Logan-Union-Champaign regional planning commission

Zoning & Subdivision Committee

Thursday, December 14, 2017

Staff Report – Darby Braeside

L:\Projects\Projects A-E\0326001\CAD\SHR\TS16 - SEPTIC PLAN.dwg - Last printed 11/22/2017 2:23 PM

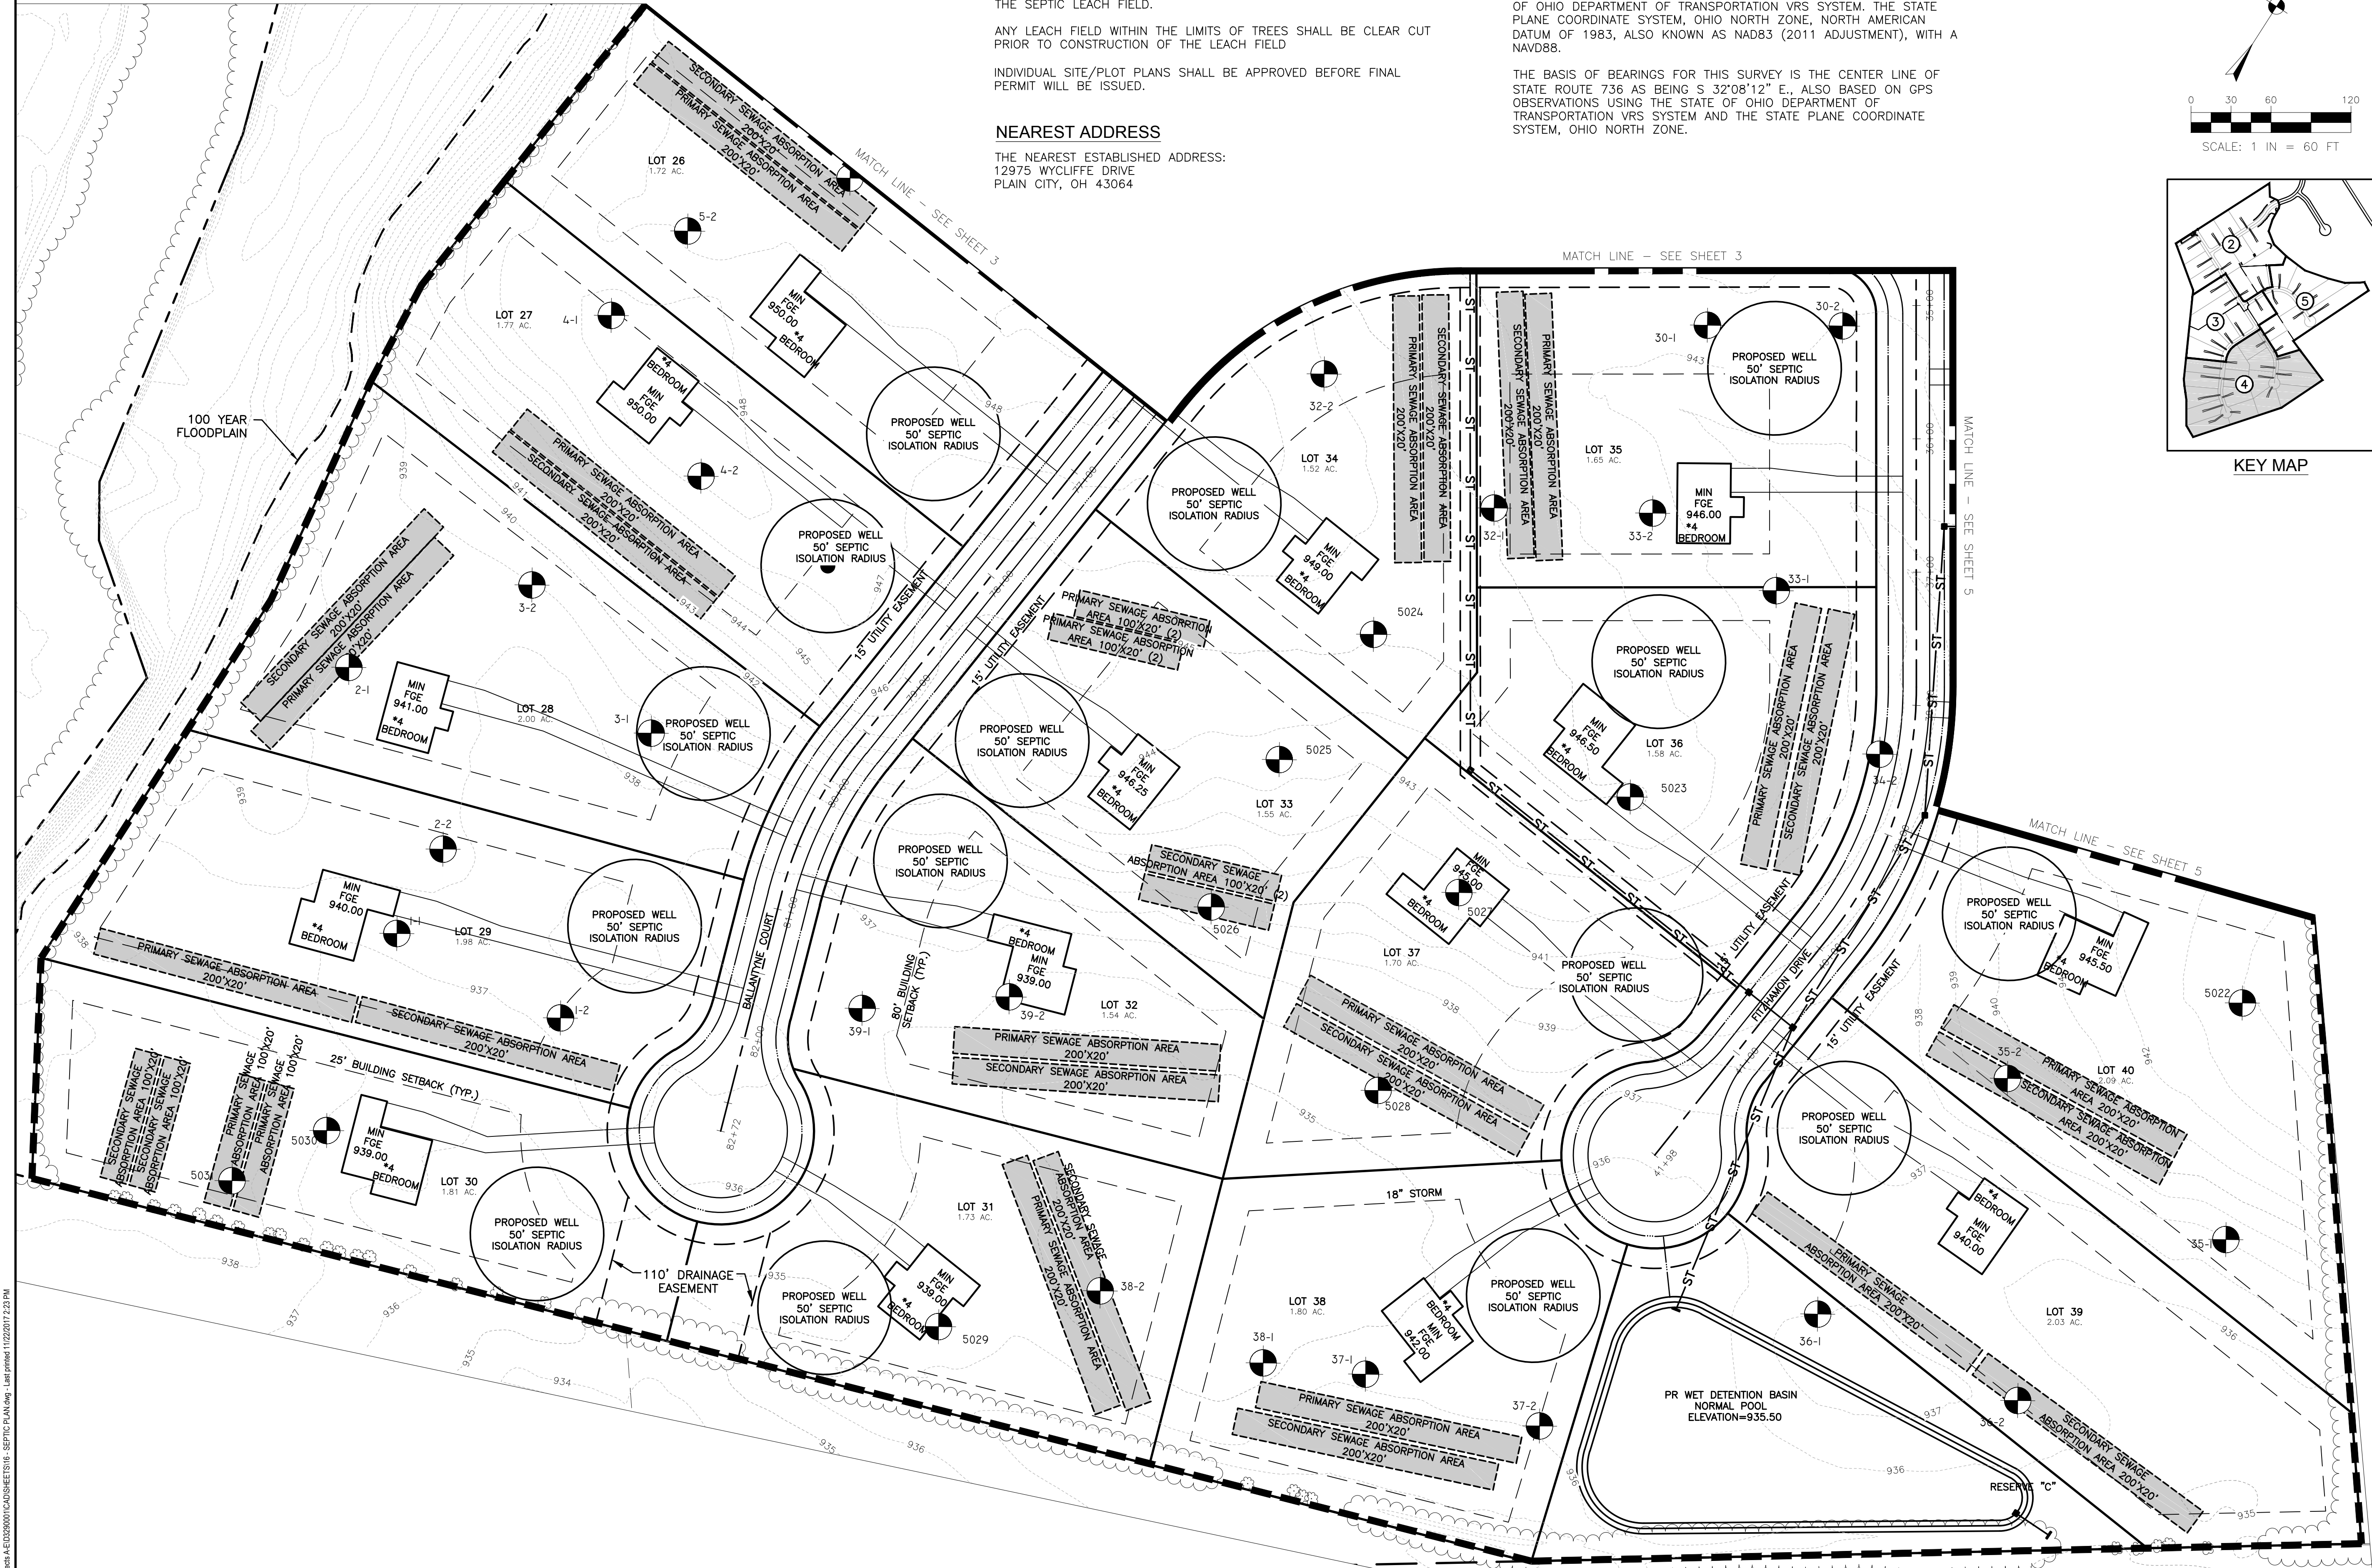
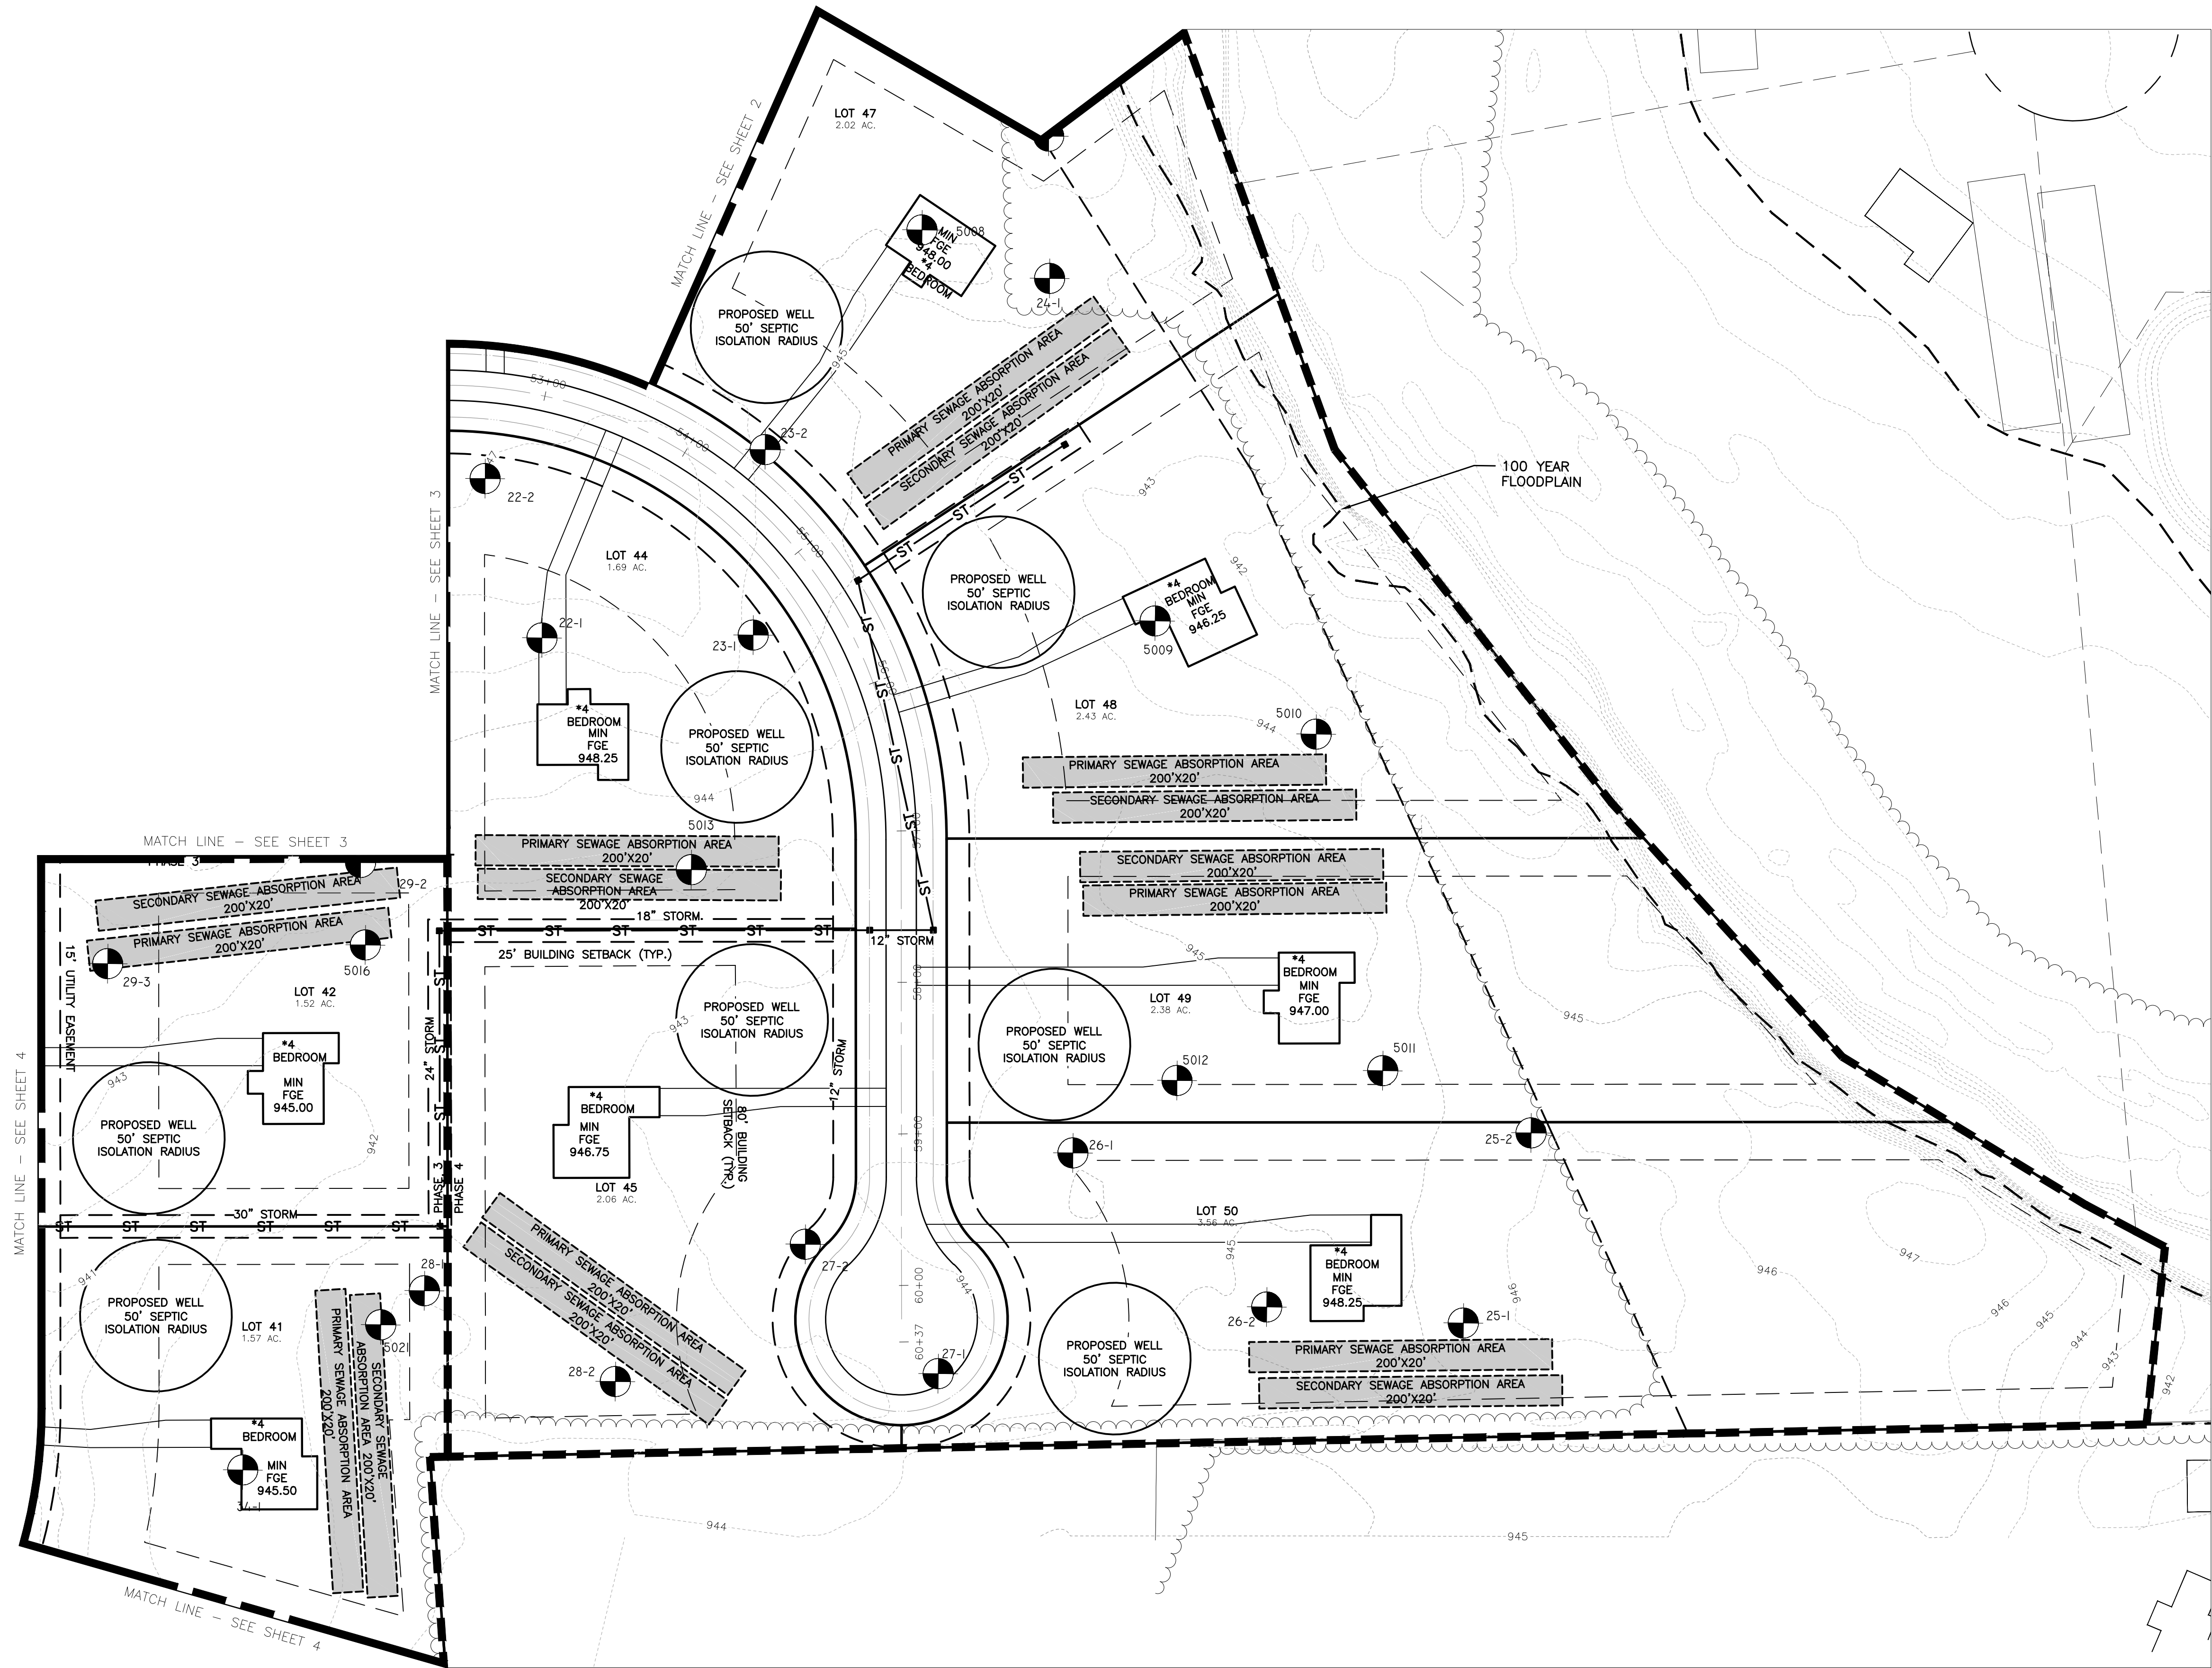
- a) Request other utility facility be noted.
- 7) Sheet 15 of 19 – SWPPP Details
 - a) No comments
- 8) Sheet 16-19 of 19 – Septic Plan
 - a) Same concerns as noted in item 5 above.
